# HISTORIC AND DESIGN REVIEW COMMISSION

**HDRC CASE NO:** 2023-050  
**ADDRESS:** 228 BARRERA  
**LEGAL DESCRIPTION:** NCB 717 BLK 14 LOT 7  
**ZONING:** IDZ, H  
**CITY COUNCIL DIST.:** 1  
**DISTRICT:** Lavaca Historic District  
**APPLICANT:** NICHOLAS MELDE/Architexas  
**OWNER:** JS&WS HOLDINGS LLC  
**TYPE OF WORK:** Construction of a 2-story residential structure  
**APPLICATION RECEIVED:** January 27, 2023  
**60-DAY REVIEW:** Not applicable due to City Council Emergency Orders  
**CASE MANAGER:** Rachel Rettaliata

The applicant is requesting a Certificate of Appropriateness for approval to construct a new 2-story, single-family residence totaling approximately 1,875 square feet with an attached carport.

**SITE PLAN**  
SCALE: 1/4" = 1'-0"

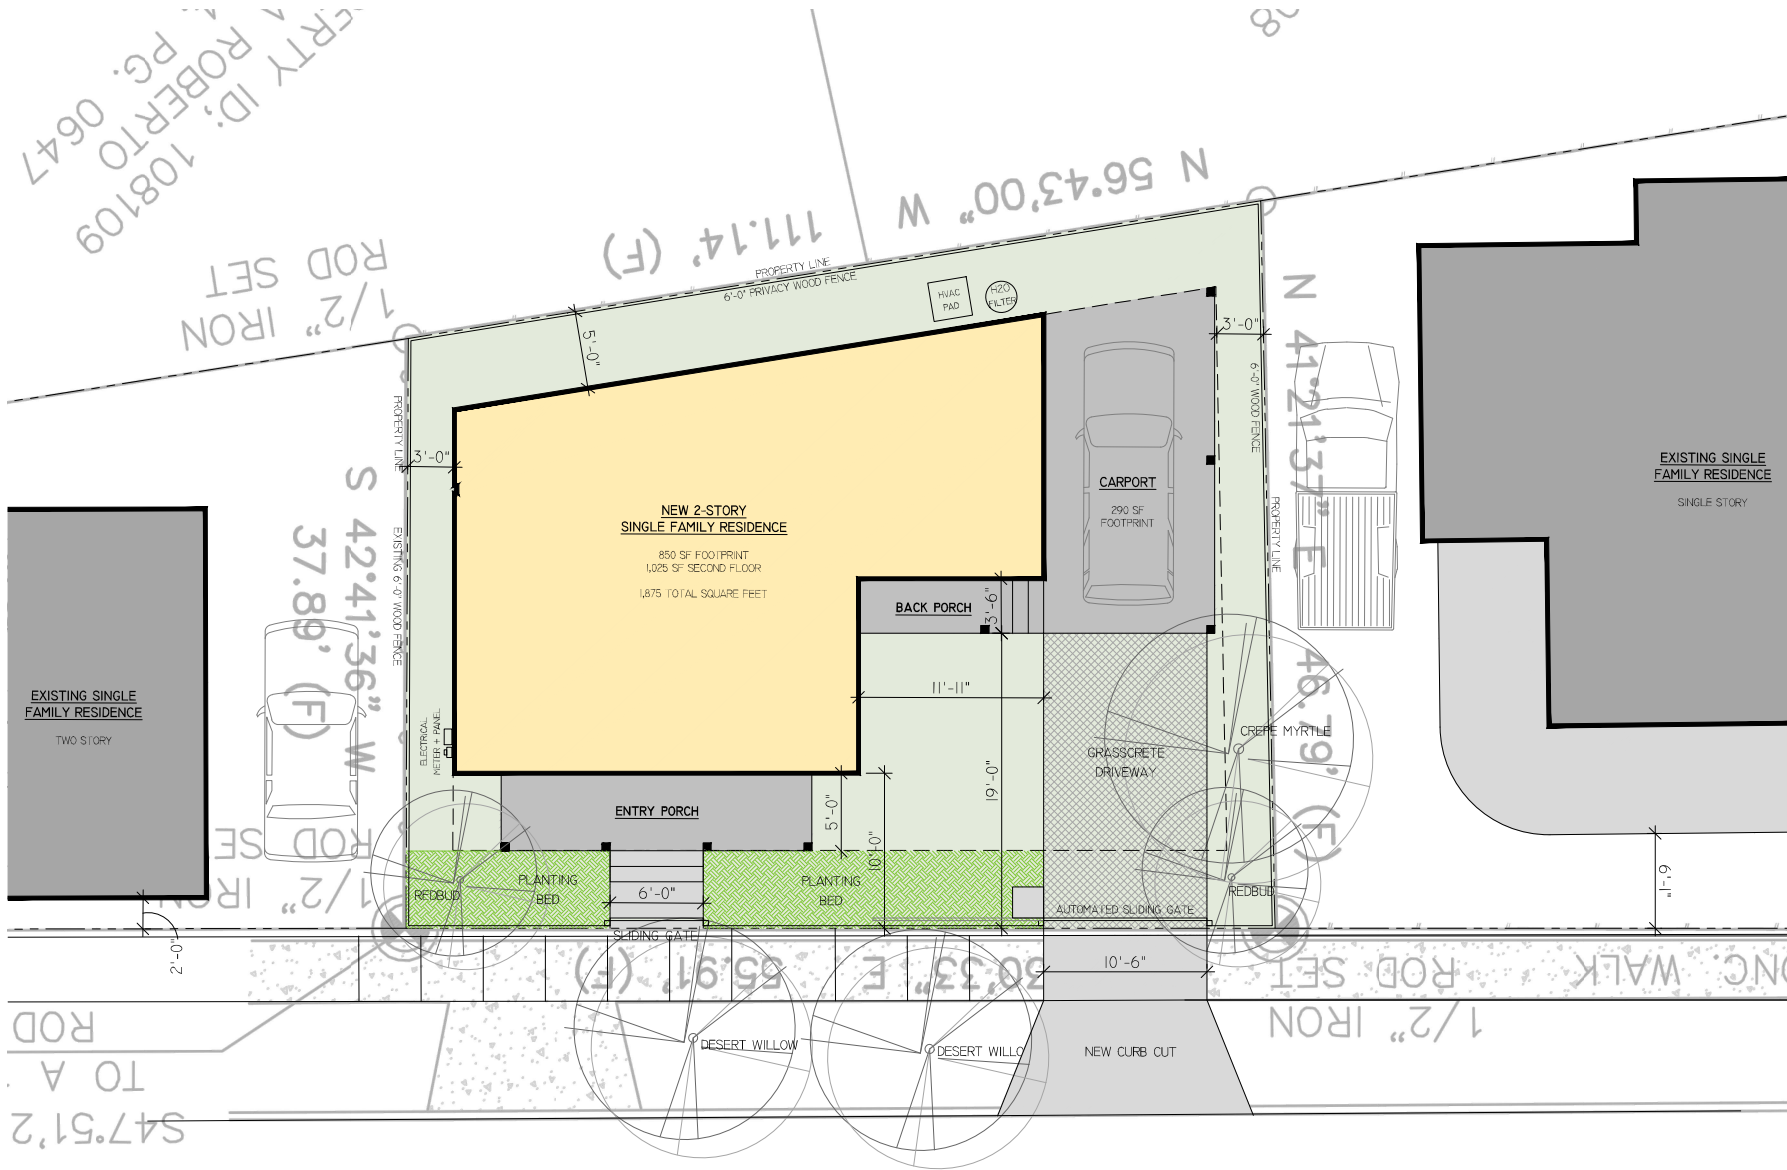
- ii. That the applicant installs a fully concrete, continuous front walkway rather than a walkway constructed of concrete pavers based on finding n. An updated site plan must be submitted to staff for review and approval prior to the issuance of a Certificate of Appropriateness.
- iii. That the applicant submits a final landscaping plan with planting bed details and material specifications for the driveway and pedestrian gates to staff for review and approval prior to the issuance of a Certificate of Appropriateness as noted in finding p.

Sheet Name  
EXTERIOR ELEVATIONS

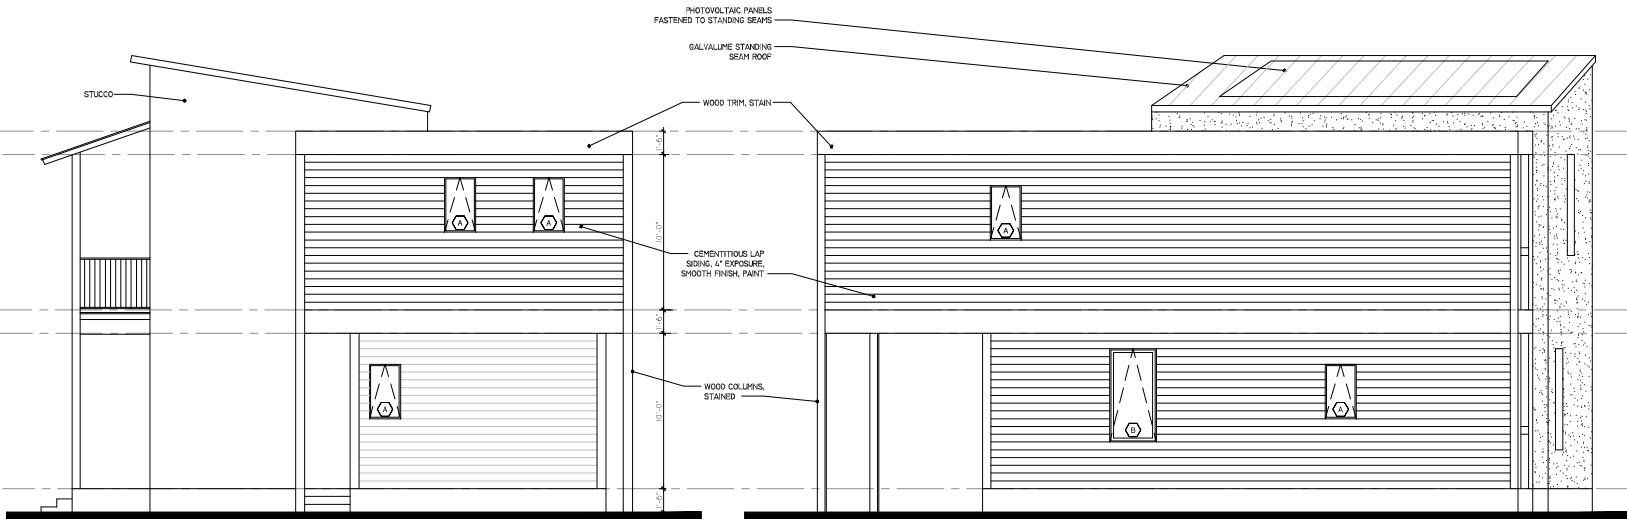
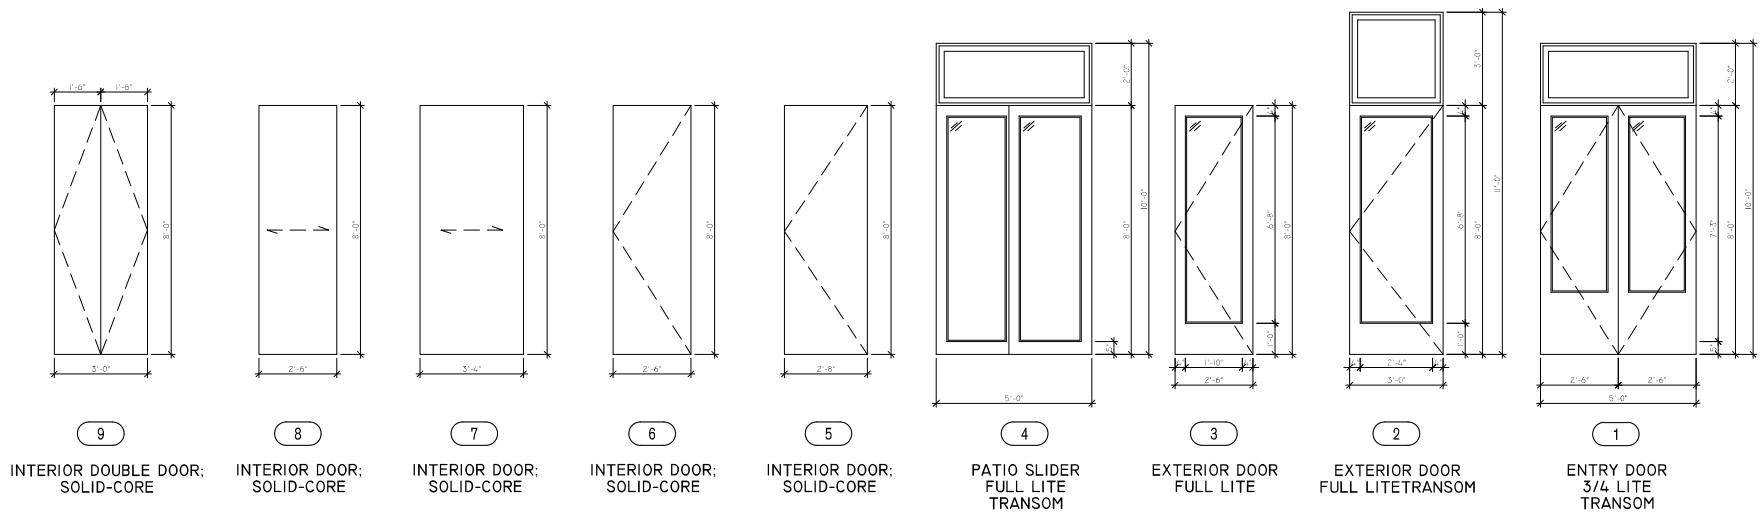
NM: Looking to increase the glazing on the front façade and potentially unite the clerestory windows on the second level with the transoms for a continuous panel of glass for the north downtown views. We have a similar massing and form but a lot more glass here, wider openings, taller transoms, goes along more with the rhythm of the porch. We wanted to get your comments back on that and then we can move on to the secondary massing and the materials. Wanted the group's perspective on the amount of glazing here.

JF: I am ambivalent about making this façade look more like a commercial storefront as opposed to a residence.

MS: I do miss the elemental subdivision of that elevation.

MS: I do agree with Jeff's observation, because the elevation is so regular that it looks storefront-like.

JF: I think that the volume should be studied to see what feels right. I think that the previous elevation had openings that felt like punched openings, that should be reinforced in the new design. Changing back to stucco between the openings would be appropriate. What is the best proportion between glass and solid?

LG: The eave of the porch is appropriate to the neighborhood. When you raise that it looks more modern.
